Expo Line Phase 2 Scoping Comments

Friends 4 Expo Transit
P.O. Box 64943, Los Angeles, CA 90064
www.friends4expo.org
April 2, 2007

- **Overland Ave. underpass**

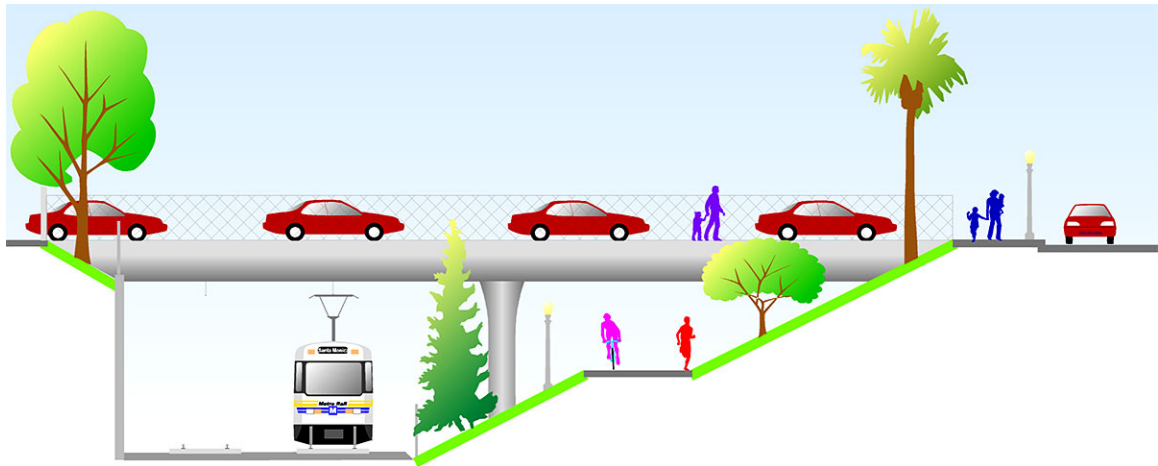
Traffic volumes on Overland Avenue appear to exceed the criteria for specifying a **grade separation** in the 2003 *MTA Grade Crossing Policy*. A local EIR counted a 2005 PM peak on Overland southbound below Pico of 2,617 (1,309 per lane), which exceeds the upper Threshold 3 into “Grade separation usually required”.

Overland Avenue Elementary School (right in photo) borders Overland and Northvale Avenues (as Charnock Road Elementary School borders Sepulveda Boulevard). Planning for **student safety** is crucial at all school locations.

These **power lines** along Overland would need to be relocated for an aerial grade separation. They are also a counterpoint to objections about light rail overhead catenary wires.

It has long been a compelling idea to **extend the existing trench** to an **Overland light rail and bike path underpass**, as in this sketch:

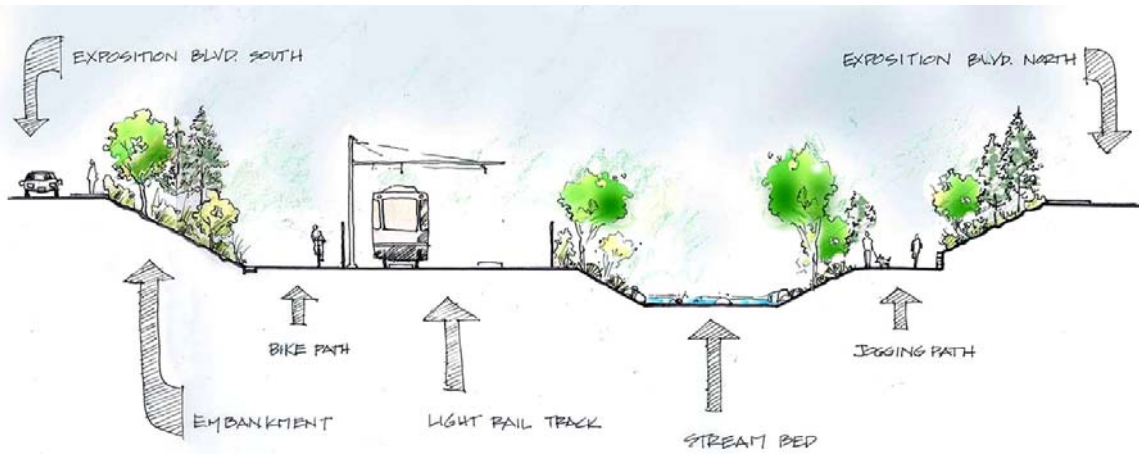
There is, however, the complication of a large concrete box **storm drain** running under Overland. Its outside dimensions are 11'-9" high x 12'-8" wide, with its top about 5 feet below the old rail tops¹. An 18" main sewer parallels it about 4 feet deeper.

A new **inverted siphon** section is a possibility for carrying storm flows below depressed light rail tracks under Overland.

Storm drain water would flow into a new “daylighted” **streambed** connecting the Overland, Military, and/or Midvale-Kelton storm drains, to percolate into the soil. Flow could be west-to-east to follow the slope down to the Overland underpass. Here are two concept sketches, courtesy of Light Rail for Cheviot:

Use of the wide right-of-way for this configuration of light rail tracks in a shallow, soil-lined trench with short underpass structure may be **no more costly**, and is certainly **much less visually impacting** than a conventional overpass with retained-fill ramps edged with soundwalls. **Water quality funds** may complement transit funds for this.

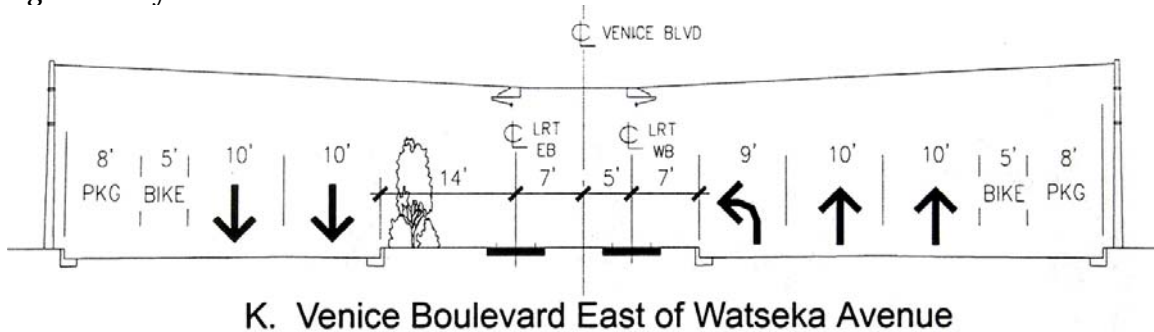
Venice Boulevard between Robertson and Culver Boulevards (shown here looking west) is very congested, with three lanes in each direction and double left turn lanes.

An **aerial alignment** from the Culver City station west of the historic Ivy Substation may be needed here, although even space for columns would be difficult.

The Venice Blvd. section drawing (below) from the 2001 *Draft EIS/EIR* (Figure 2D-7) shows **loss of one traffic lane** in each direction. Additional impacts to **cross traffic, parking, and adjacent businesses** that appear to be using former Venice Boulevard right-of-way should be studied.

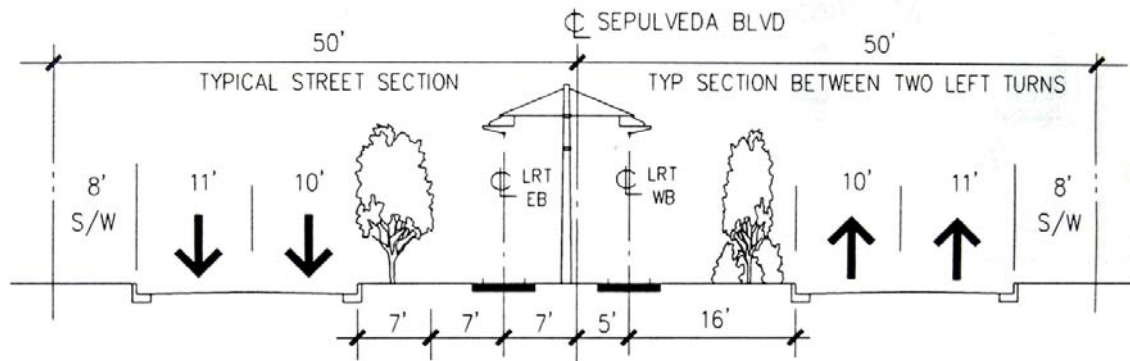
The intersection of Venice and Sepulveda Boulevards is very congested at peak periods, and would likely delay trains waiting for their turn signal phase.

Travel time estimates based on the current Blue Line schedule suggest this route may be as much as **10 minutes – 25% – slower** due to its one-mile-longer length, 35 mph vs. 55 mph top speed, and intersection delays.

An **aerial curve** here is a possible mitigation (and could transition into the **hill** visible on Sepulveda, eliminating that steep grade). If considered, it should be planned **not to preclude a future extension** farther west on Venice Boulevard.

P. Olympic Boulevard West of 20th Street

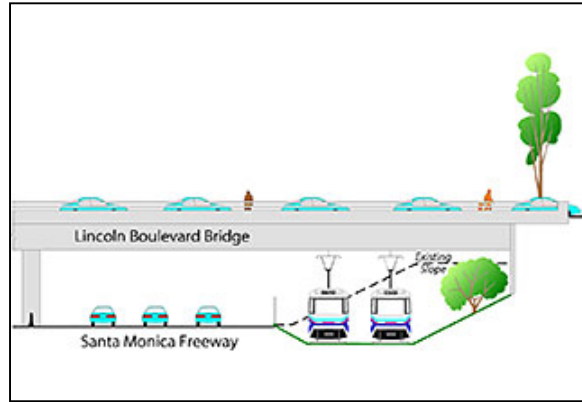
The **grass and coral tree median** of Olympic Blvd. in Santa Monica west of 20th Street is a local landmark. The 2001 *Draft EIS/EIR* (Figure 2D-10) suggested the tracks be next to the median and would preserve the trees (above). Safety, speed, and less traffic here **support a dedicated track lane**, not the 2001 **mixed flow** proposal.

There should be a **third Santa Monica station added around 14th-17th Streets** to serve the mid-city area, especially Santa Monica College to the south and Santa Monica-UCLA Medical Center to the north, as well as the dense population and many other adjacent businesses here. Lighter local traffic makes this a good location for **parking**.
